The Regular Meeting of the  
**Brian Head Planning Commission**

1. **PUBLIC HEARING: Aspen Meadows Christmas Tree Neighborhood and Nordic Center Preliminary Plat** - Greg Sant, Planning and Building Administrator.
2. **ADMINISTRATIVE ACTION: Aspen Meadows Christmas Tree Neighborhood and Nordic Center Preliminary Plat** - Greg Sant, Planning and Building Administrator.
3. **DISCUSSION ON FUTURE LMC ITEMS TO BE PUT ON AGENDA: Parking and Sign ordinances and Potential Transitional Residential Zoning Locations.**

**AUTHOR:** Greg Sant  
**DEPARTMENT:** Planning and Building  
**DATE:** February 3, 2026  
**TYPE OF ITEM:** Administrative Action

# ALPINE CHRISTMAS TREE AREA - PHASE 1 CHRISTMAS TREE RIDGE AND NORDIC CENTER PRELIMINARY PLAT

**ALPINE CHRISTMAS TREE AREA - PHASE 1  
CHRISTMAS TREE RIDGE AND NORDIC CENTER  
PRELIMINARY PLAT**  
LOCATED IN THE SOUTHEAST QUARTER OF SECTION 36, TOWNSHIP 35 SOUTH,  
RANGE 9 WEST, SALT LAKE BASE AND MERIDIAN  
BRIAN HEAD, IRON COUNTY, UTAH

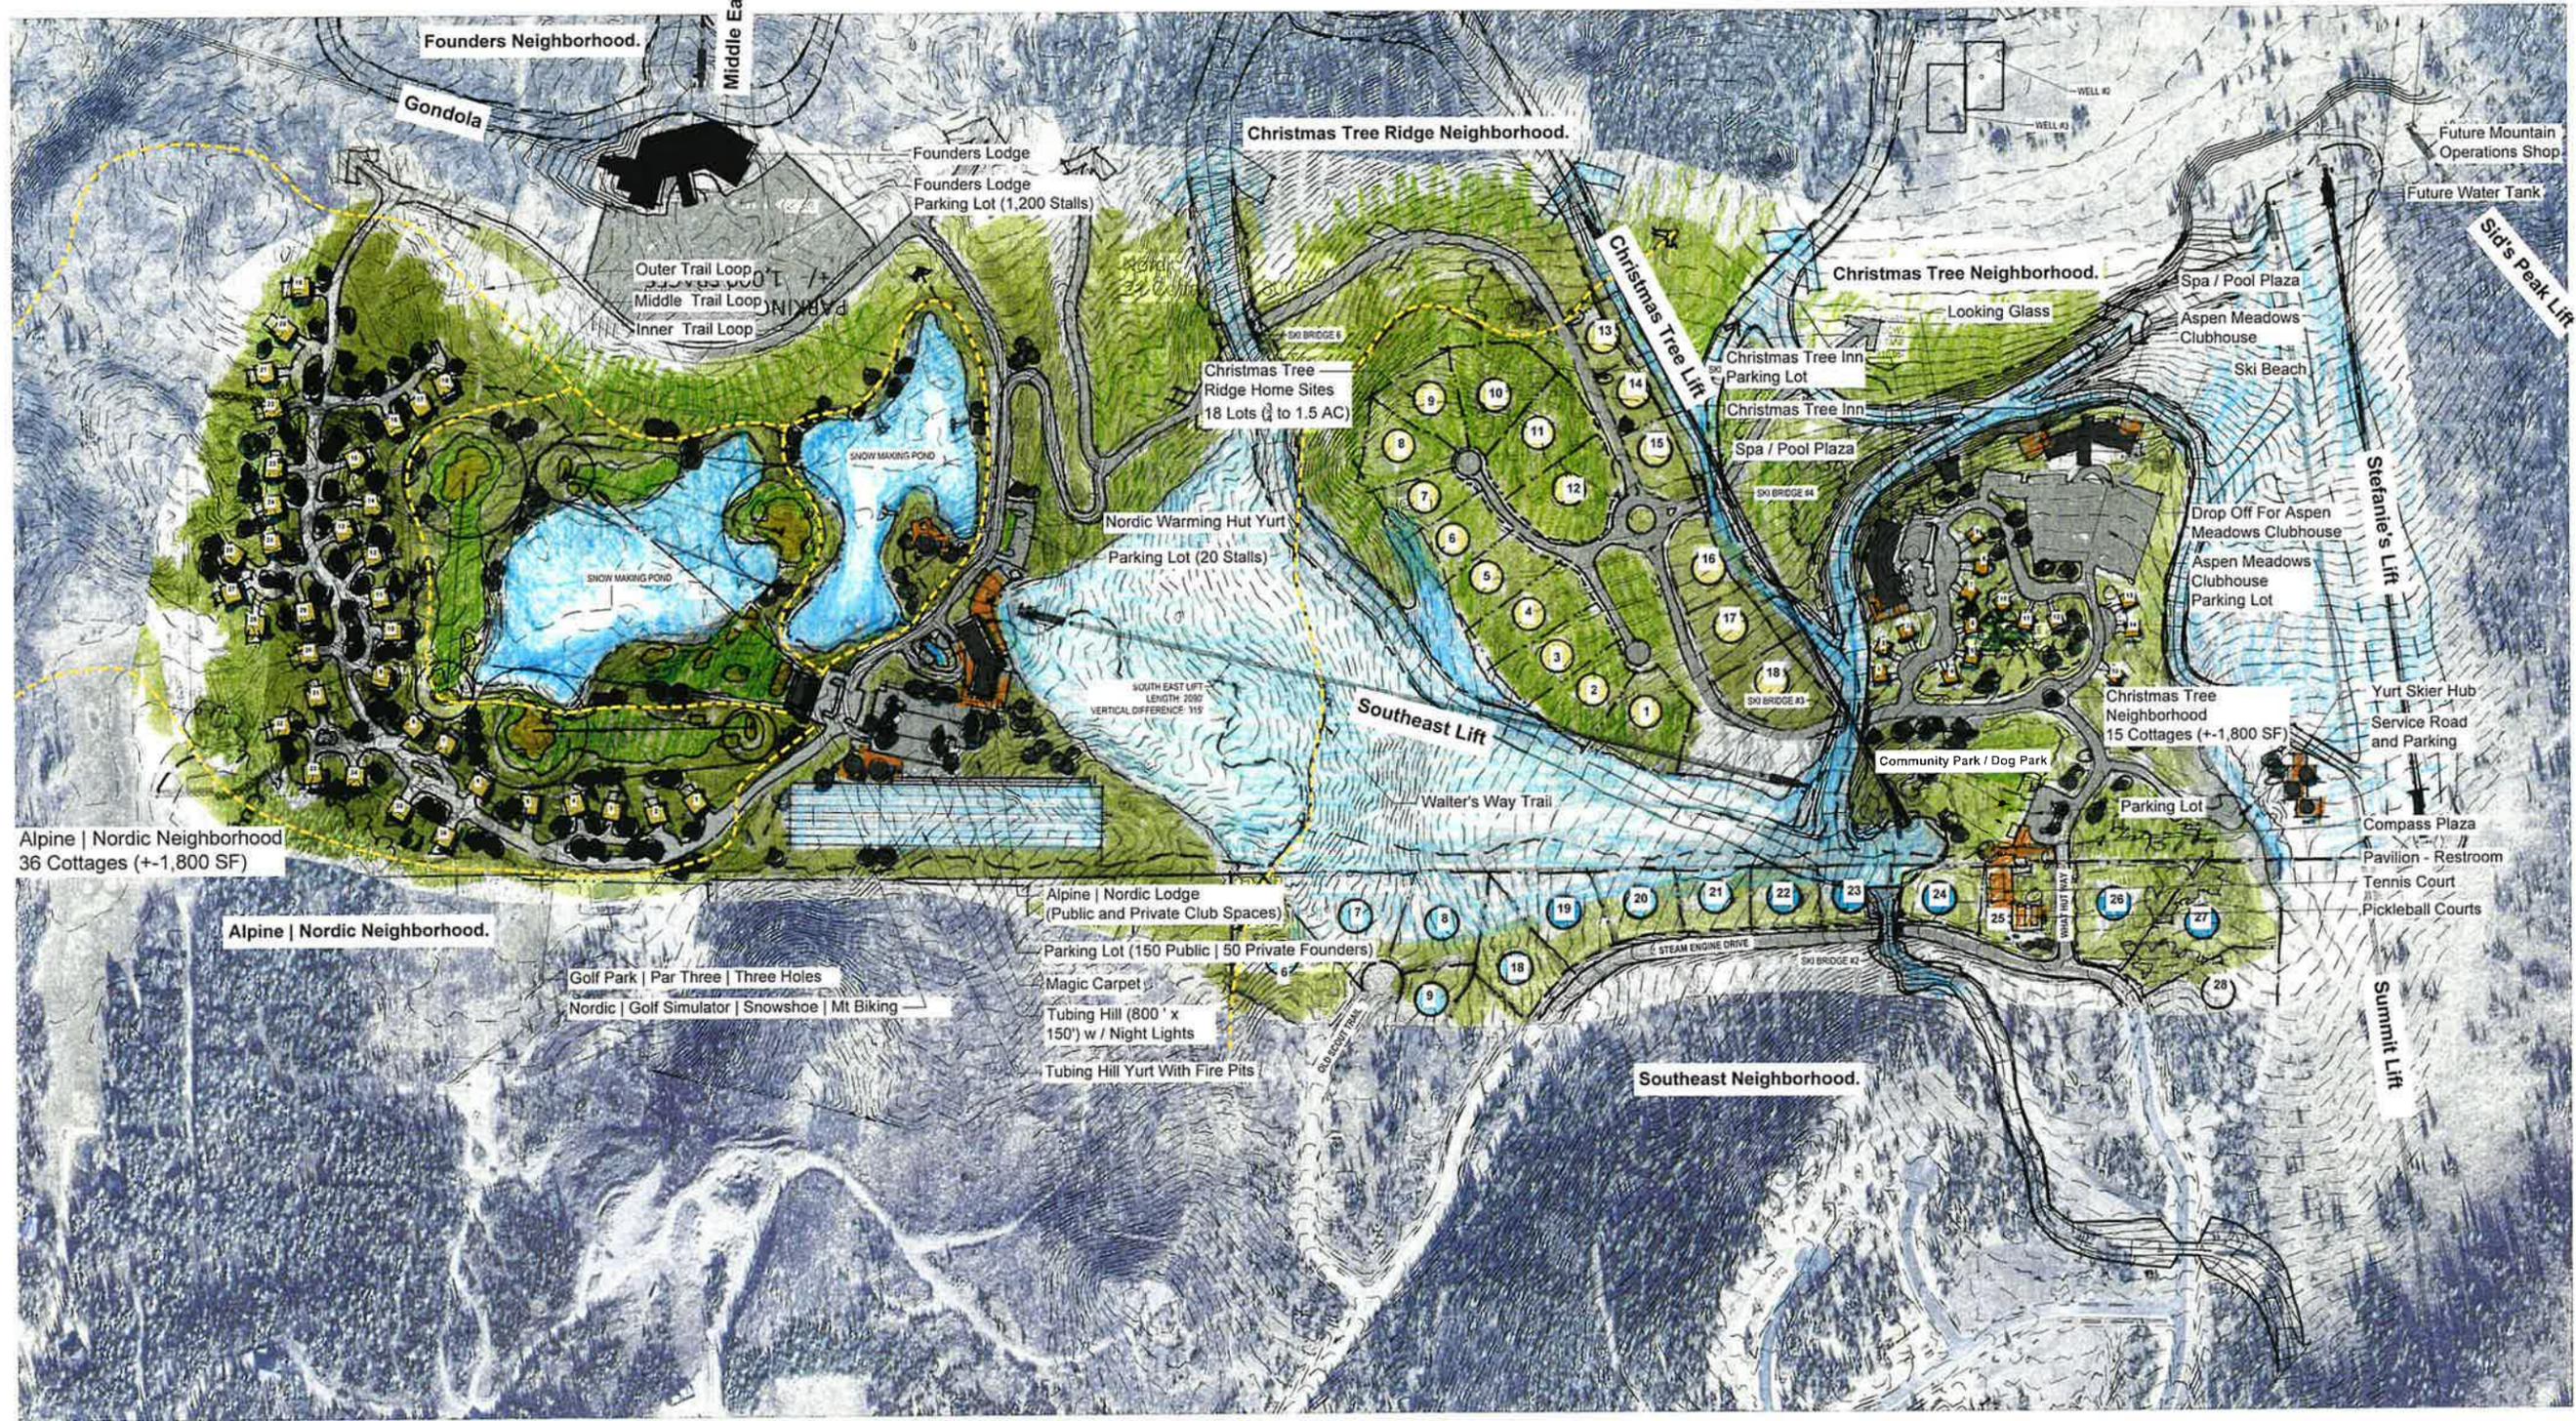
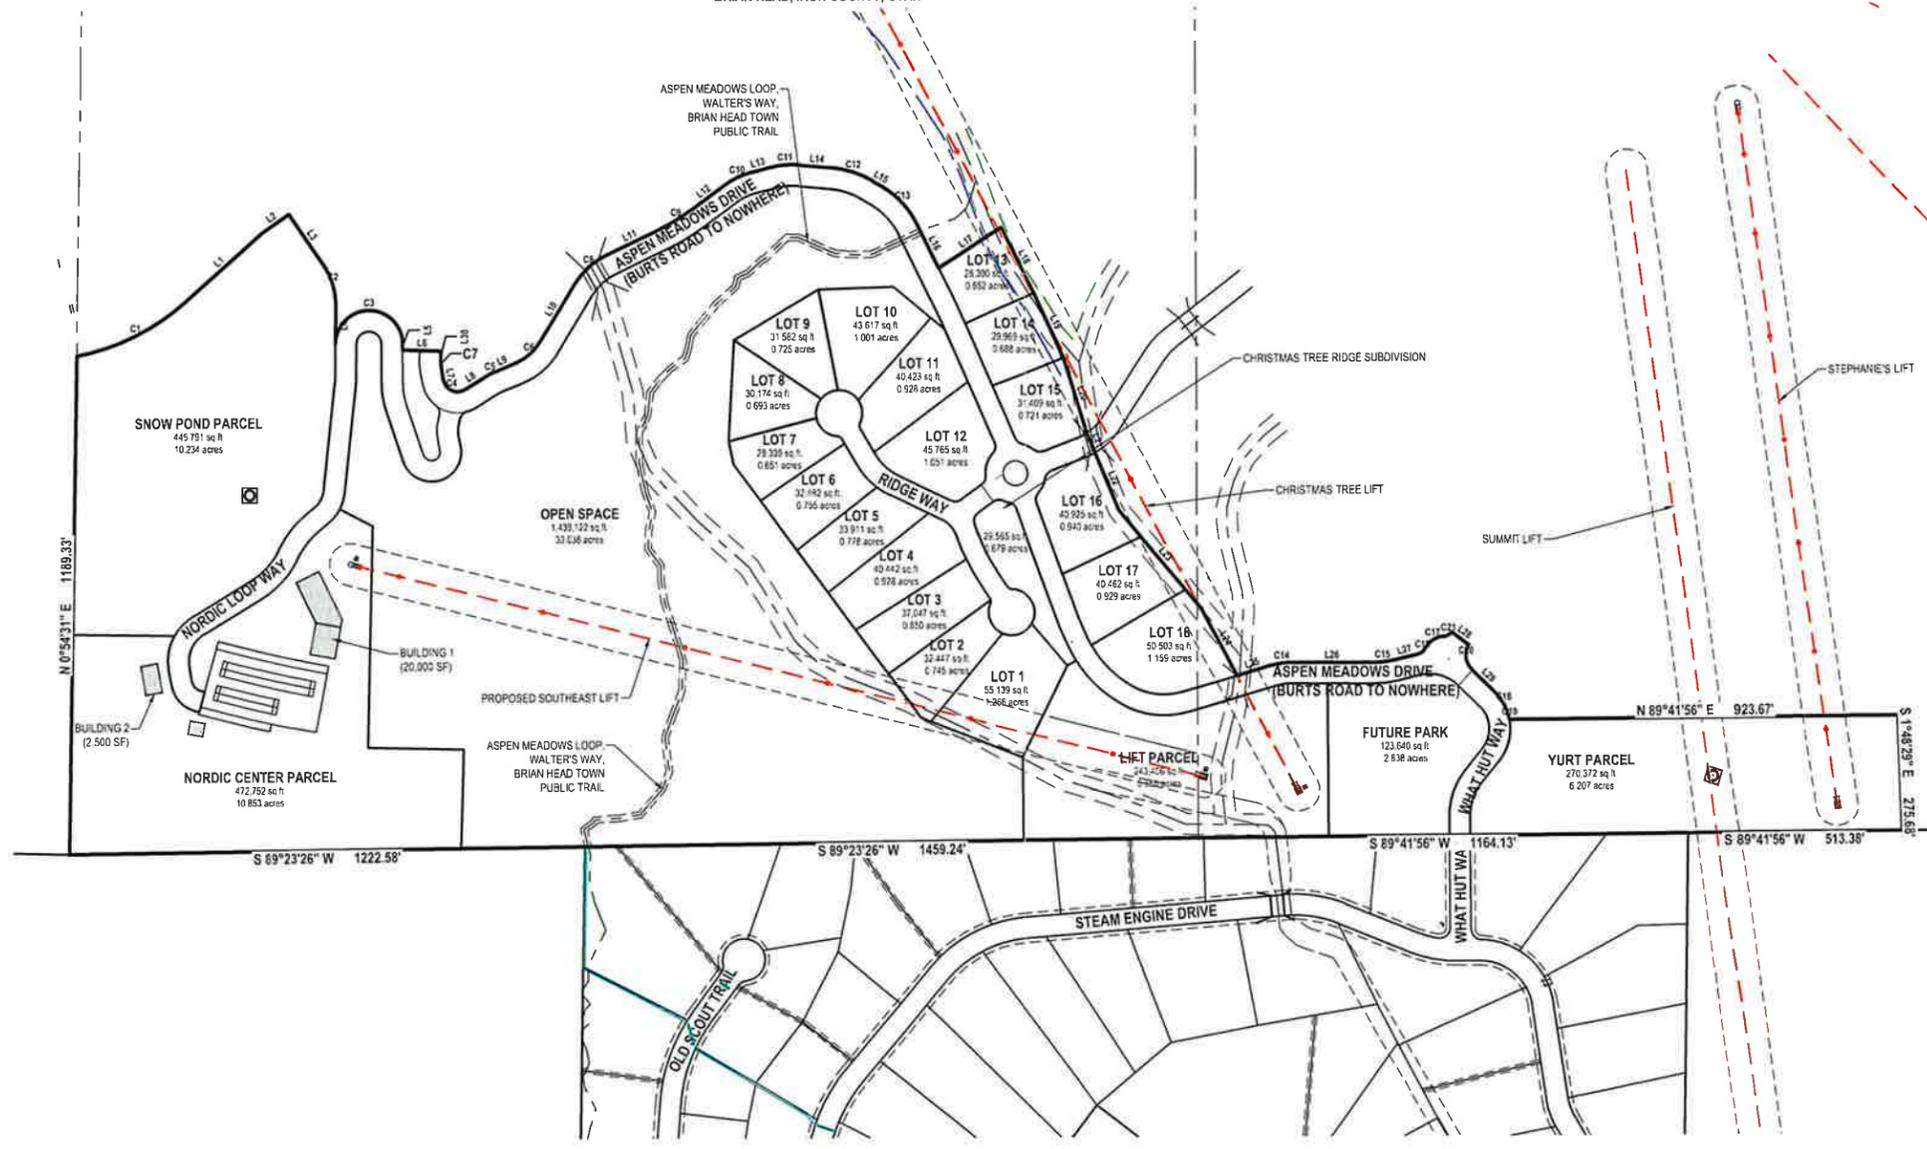
- (1) The lots on the Preliminary Plat do not show lot line measurements therefore, it is hard to determine if they meet the required frontage length.

- (2) There is not two (2) points of access or egress called out as required by 9-12-9 A(4). Once Burts Road to Nowhere is installed to meet up with Aspen Meadows Dr. this issue will be resolved. Staff recommends including appropriate notes to call out this secondary access and ensure it is accessible to residents and visitors of the neighborhood as well as emergency response personnel.

- (4) Aspen Meadows Dr. is approximately one (1) mile in length and lacks the adequate number of turnarounds as required in 9-12-9 A(12.b). Again, once Burts Road to Nowhere is installed and meets up with Aspen Meadows Dr., this issue will be resolved.

- c. Public Services for the Preliminary Plat and Exhibits were reviewed by the Public Works Department, and they offer the following comments:
  - i. Water: Potential issue with the dead-end of the water line that extends to the commercial piece, however, in the long-term, once Aspen Meadows Dr. and the utilities are extended down to Burt's Road to Nowhere then this will be a short dead-end and would be acceptable. There will be some water pressure issues that will require PRV's, but as long as the developer follows Town Standards it will be acceptable.

- d. Public Safety has reviewed the Preliminary Plat and Exhibits and have offered the following comments: Fire Hydrants must be placed per Town Standards, Second Access/Egress needs to be addressed, and Turnarounds need to be addressed.

1. The Preliminary Plat needs to be revised to show the Lot Dimensions.
2. There needs to be a resolution regarding the second access that is required by the LMC. This could be a temporary access through other property owned by the Applicant, requiring Burt's Road to Nowhere to be developed within a certain time, etc. Along with this discussion, the need for turnarounds needs to be addressed.
3. There needs to be a time by which a Traffic Study would be completed in order to address questions that might arise from UDOT and citizens along Steam Engine Dr.
4. A Zone Change application needs to be submitted by the Applicant, and the Zone Change must be completed before the Preliminary Plat would be approved.
